Viva Energy Clyde Western Area Remediation Project - Stage 1

2 Durham Street, Rosehill, NSW Site Audit Report

June 2020

FIGURE 8-1: HYDROCARBON EXCEEDANCES IN SOIL 0-1M BGL

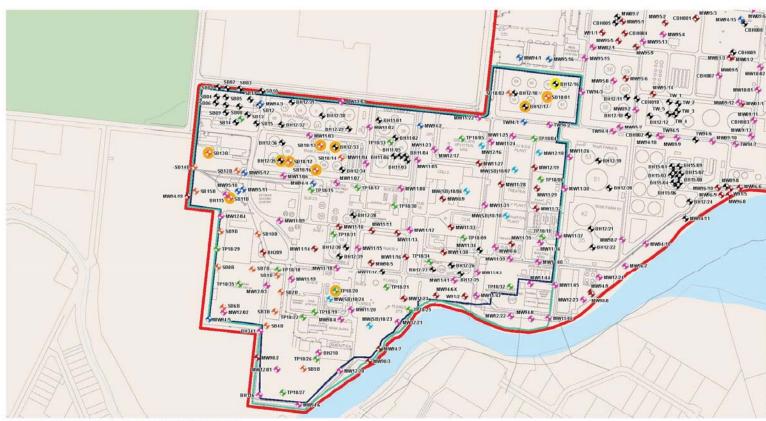
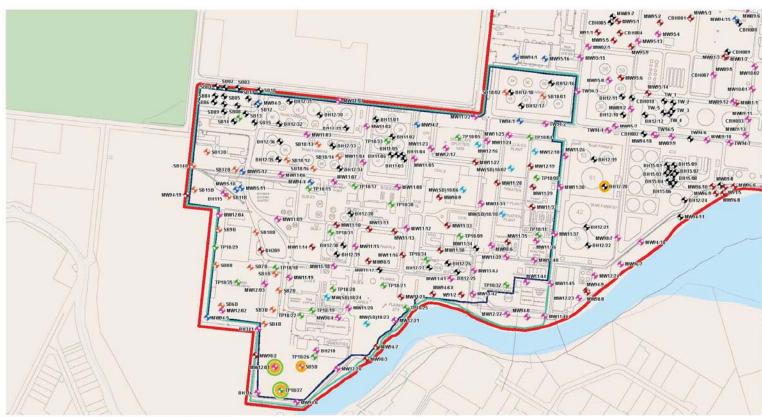
- A figure showing the areas where the contaminated soils will be removed is required.
- A figure showing the areas impacted by PFAS, dioxins and asbestos (soil and groundwater) is required.
- Figures 8-1 to 8-3 from the Conceptual RAP are different to the corresponding figures presented in the TSI report (Figures 8 to 10).
- Based on Figure 8-5 the following points need to be clarified:
 - What are the adopted criteria that have been exceeded?
 - Naphthalene is a petroleum hydrocarbon. However, it was reported in Figure 8-5 as a non-petroleum COPCs.

| Adopted assessment criteria | |
|--|--|
| The above information should be clearly shown on cross sections with annotated data. The information provided in Figures 8-1 to 8-3 is different to above described. | Not required at this conceptual stage. Will be provided in the Detailed RAP adopting the site-specific validation criteria and in defining the Remediation Extent. The RAP figures has been amended to show exceedances only and the Section 9.2.1 text updated accordingly. |

| | AECOM Imagin Delive |
|---|--|
| Figures 8-1 to 8-3 from the Conceptual RAP are different to the corresponding figures presented in the TSI report (Figures 8 to 10). | The RAP figures have been amended to show exceedances only. |

FIGURE 8-5: OTHER COPC EXCEEDANCES IN GROUNDWATER (2013 AND 2017)

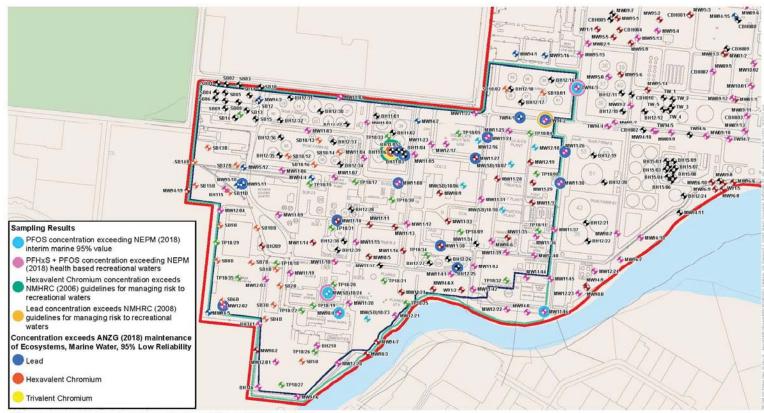
| | AECOM Imagin Delive |
|---|--|
| Based on Figure 8-5 the following points need to be clarified: | |

| | AECOM Imagin Delive |
|---|--|
| Naphthalene is a petroleum hydrocarbon. However, it was reported in Figure 8-5 as a non-petroleum COPCs. | The Figure 8-5 title will be changed to "Other COPCs". |

Figure 8-6 Conceptual Site Model

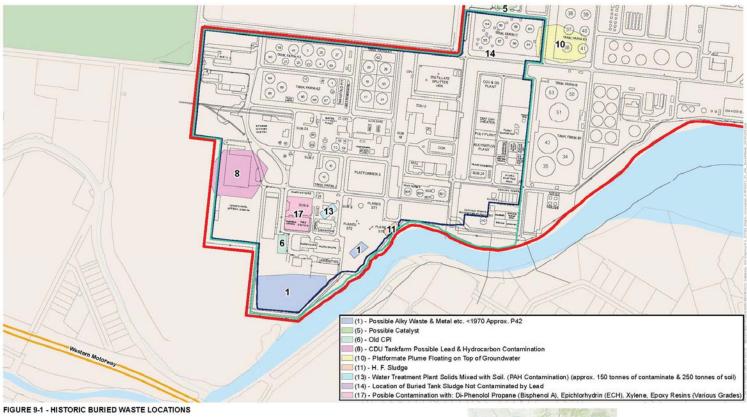
- Although Figure 8-6 illustrated the CSM for the site, a more robust CSM including the complete exposure pathways should be provided. As a guide, the Targeted Site Investigation (TSI) report presented a CSM (Section 6) that could be used in the Conceptual RAP after appropriate revision.
- The CSM presented in the TSI report identified the Duck River as an off-site ecological receptor. Therefore, the Conceptual RAP should present discussion regarding this receptor, especially as high concentrations of lead, dioxins and PFAS (up to 1.8 ug/L) in groundwater samples collect in the monitoring wells located close to the river.
- Given that dioxins have been identified in soils on site, commentary on whether a site-specific assessment of exposure to all PCBs (including dioxin-like PCBs) and dioxins (as per NEPM requirements) is necessary.

| Ref. | Site Auditor comment | AECOM Response |
|------|---|--|
| | • Although Figure 8-6 illustrated the CSM for the site, a more robust CSM including the complete exposure pathways should be provided. As a guide, the Targeted Site Investigation (TSI) report presented a CSM (Section 6) that could be used in the Conceptual RAP after appropriate revision. | Agreed - the table has been added to Section 8.4 and modified. |

Figure 15-1 Project Area Proposed Remediation Layout

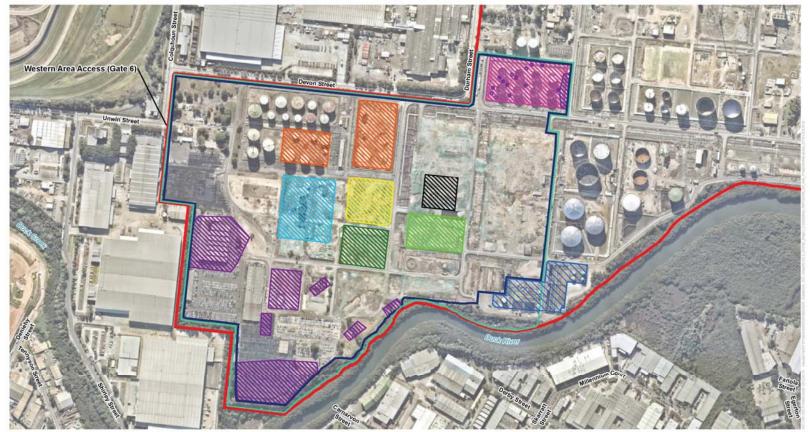
- The Conceptual RAP needs to show areas of contamination requiring remediation, calculations and assessment/action levels used in the calculations. Figure 15-1 only shows areas where remediation may take place.

| Re | emediation | |
|----|--|--|
| • | The Conceptual RAP needs to show areas of contamination requiring remediation, calculations and assessment/action levels used in the calculations. Figure 15-1 only shows areas where remediation may take place. | Not required for a conceptual plan. The 3D modelling report shows areas of hydrocarbon impacts based on current data sets. The Remediation Extent will be detailed in Detailed RAP based on adopting the site-specific validation criteria (post HHERA). |
